AMENDMENT OF SOLICITATION/MODIFICATION OF CONTRACT

2. Wage Rates.- Replace wage rate pages 00710-1 through 00710-3 with the attached pages 00710-1 through 00710-4, each page bearing the notation "ACCOMPANYING AMENDMENT NO. 0001 TO SOLICITATION NO. DACW63-02-B-00004."

3. Section 01000 - Replace this Section with the accompanying new Section bearing the notation "ACCOMPANYING AMENDMENT NO. 0001 TO SOLICITATION NO. DACW63-02-B-0004:"

**Specifications for Replacement of Generator Piping and Twin Strainers
at Sam Rayburn Power Plant, Sam Rayburn Reservoir, Jasper Texas**

SRPR 1

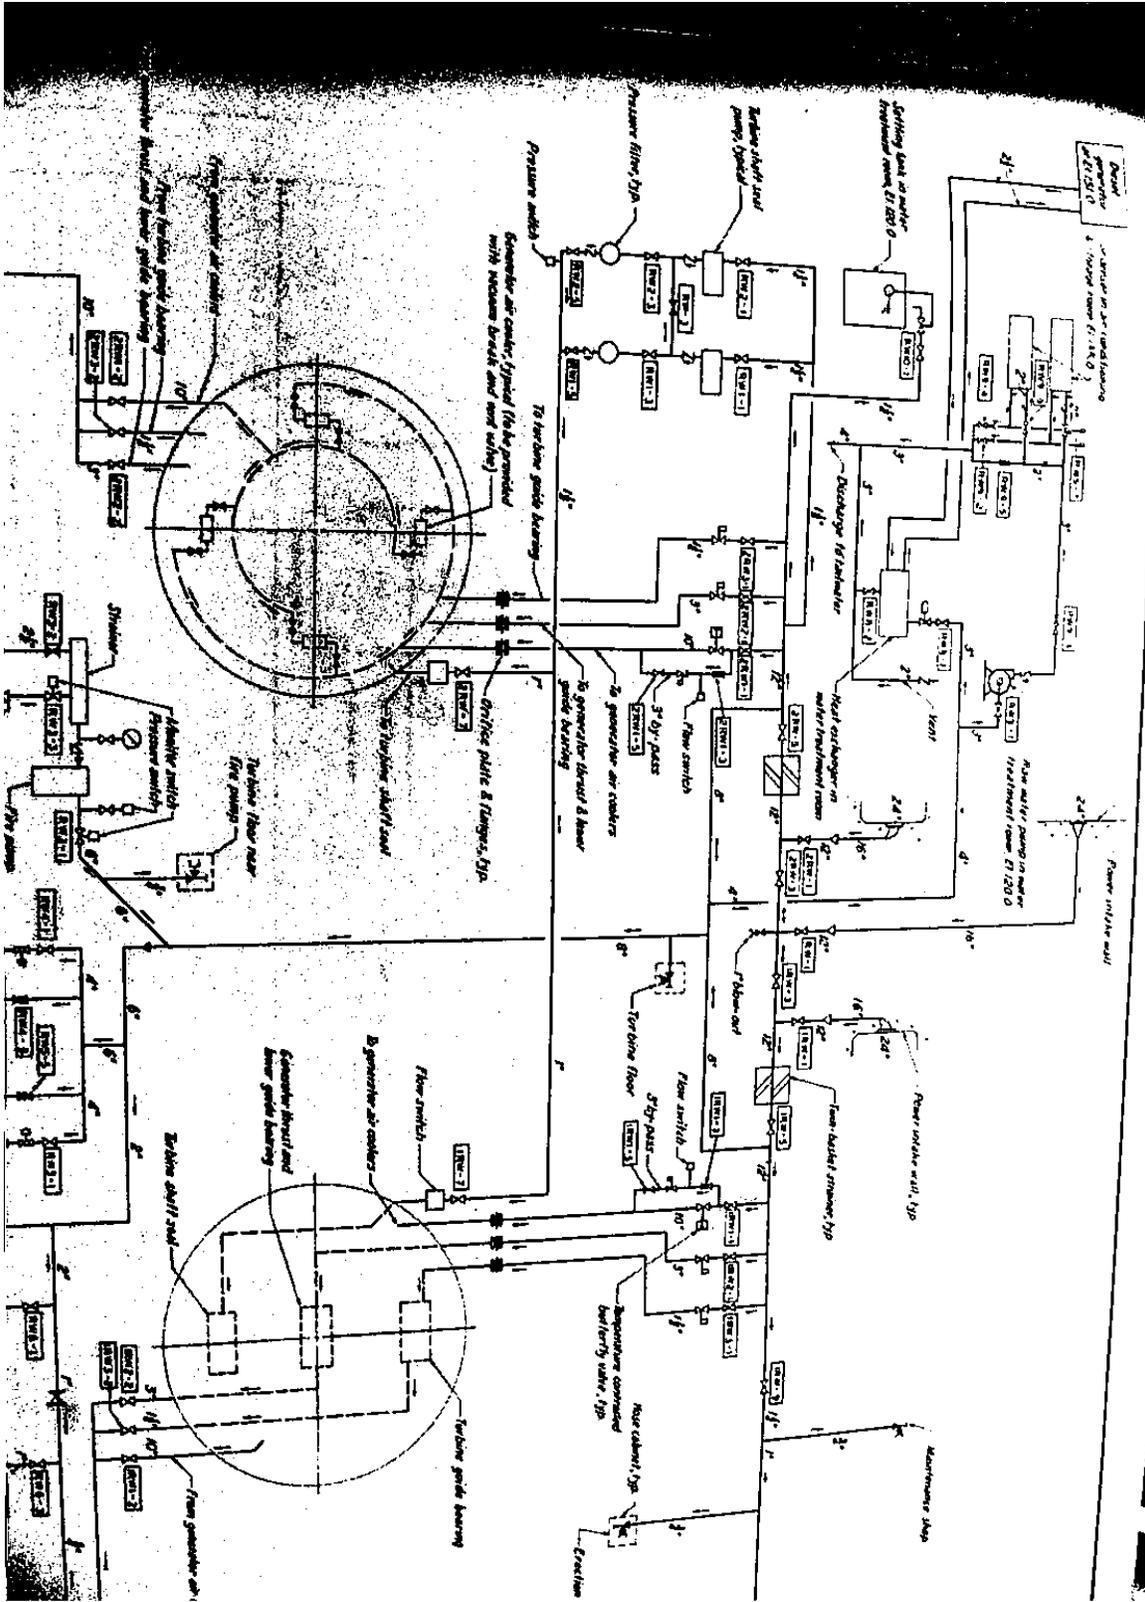
A. Another set of flanges and gate valves at two locations on the 6 inch piping which Tees off from the 12” lines on each generators side of the water system (total of two 6” gate valves and four new flanges). The location of the newly installed valves shall be at the point annotated on the drawing SRPR1 as “2.2.A”.

B. A change in location of two of the 2" taps into the 6" pipe. The existing 1 1/2" welded taps into the 6" line (near point annotated as 2.2.a) shall be removed from the 6" lines and shall be connected at the points annotated on the drawing SRPR1 as "2.2.B". This shall be accomplished by installing a new Tee fitting into the 1 1/2" line at the location approximately 6 ft. from the floor and then installing a gate valve and new piping and fittings to make connections to replace the 1 1/2" pipe which provides water to the two turbine shaft seal pumps. The Contractor shall install sufficient length of pipe to run the length of the piping gallery all the way back to a point at which the centerline of the entrance to the Piping Gallery intersects the two 1 1/2" water supply lines. At that point, the Contractor shall cut the two existing 1 1/2" pump supply lines and install a pipe union to connect the new stainless steel piping to the ferrous pump supply lines.
